Item Name: Replacement Skidtube (Fits LH or RH)

DRAWING NO. D2650	TITLE 206/407 SKIDTUBE ASSEMBLIES	REV. F	DART AEROSPACE LTD ENGINEERING ORDER		D.E.O. NO. D2650-F-1	SHEET NO. SHEET 1 OF 1	SCALE NTS
DRAWN <i>[Signature]</i>	CHECKED <i>A.P.</i>	MFG. APPR. <i>[Signature]</i>	APPROVED <i>[Signature]</i>		DE APPR. <i>[Signature]</i>		
DATE 12.10.12	DATE 12.10.22	DATE 12.10.22	DATE 12.10.22		DATE 12.10.22

CHANGE C'BORED WELDED CROSSBOLT SPACERS TO SWAGED SPACERS

DETAIL B

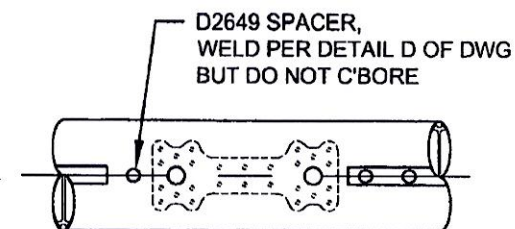
ADD DETAIL G BELOW, WHICH IS THE SAME SECTION VIEW AS DETAIL D OF DWG.

C'BORED HOLES ARE NOW SWAGED PER DETAIL G BELOW. FOR THE Ø0.375 HOLE THAT IS NOT C'BORED, WELD PER DETAIL D OF DWG (SEE AMENDED DETAIL B FOR REFERENCE).

DETAIL G

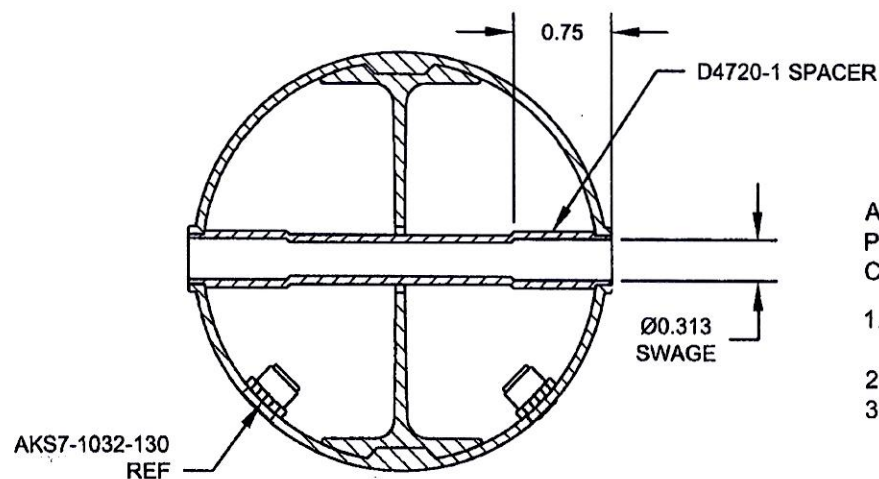
AMENDMENT TO DETAIL B
NOT TO SCALE
